#2015-33 BMO Harris Bank Northwest Hwy – Final PUD Amendment and Variation Project Review for Planning and Zoning Commission

<u>Meeting Date:</u>	August 5, 2015
<u>Requests:</u>	<ol style="list-style-type: none">1. Final PUD Amendment to allow changes to the freestanding signage,2. Variation from Article 4-1000 sign height and area to allow a 7-foot tall freestanding sign with an area of 42 square feet.
<u>Location:</u>	5545 Northwest Highway
<u>Acreage:</u>	Approximately 1.8 acres
<u>Zoning:</u>	B-2 PUD- General Commercial Planned Unit Development
<u>Surrounding Properties:</u>	North: B-2 PUD- General Commercial Planned Unit Development South: B-2 PUD- General Commercial Planned Unit Development East: M – Manufacturing (Three Oaks Recreation Area Entrance) West: B-2 PUD- General Commercial Planned Unit Development
<u>Staff Contact:</u>	Kathryn Cowlin (815.356.3615)

2015-33 BMO HARRIS BANK – 5545 Northwest Highway – PUBLIC HEARING

SIGN 1

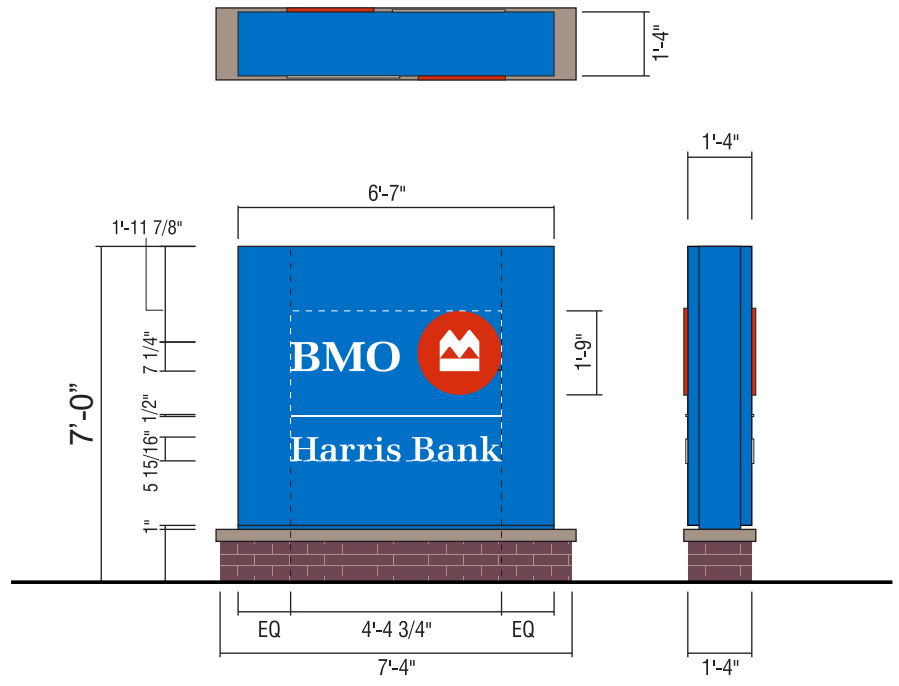
Mr. Goss said if you travel east-bound on Route 14 and can't see the sign now, then you won't be able to see the new sign either. Also, now there is a sign for the Three Oaks Recreation Area to contend with. He is in favor of meeting the UDO requirements for height and just change the font size.

Mr. Jouron said he doesn't like all of the blue that is used on the sign. He said the buildings have always been nice but this goes too far. He doesn't believe it will look good and feels it could be classier. Mr. Jouron feels the signs should meet the ordinance and be no taller than six feet.

Mr. Goss said he can't approve more than six feet. Mr. Skluzacek agreed. Mr. Esposito agreed that the sign needs to meet the ordinance. Mr. Jouron said they worked hard on the UDO and the signs should meet the ordinance. Mr. Batastini said car dealers are taller. Ms. Cowlin said banks are considered an office use. Mr. Batastini said he is ok with larger than six feet sign here. The entire area is a challenge. He added that a bank is not an impulse buy. Mr. Hayden said fair is fair and that is where he has the difficulty. There is not a lot they can do with grandfathered signs. Other signs were approved after the UDO was adopted and the City will be hearing from them if this is granted. Mr. Goss told the petitioners that the City Council has overruled the Commission more than once. Mr. Merritt said they can delay another month and come back to the Commission but he thinks they will take their chances at the City Council. He doesn't want this to become a football. He would prefer to have the Commission's support but wants to move forward to City Council.
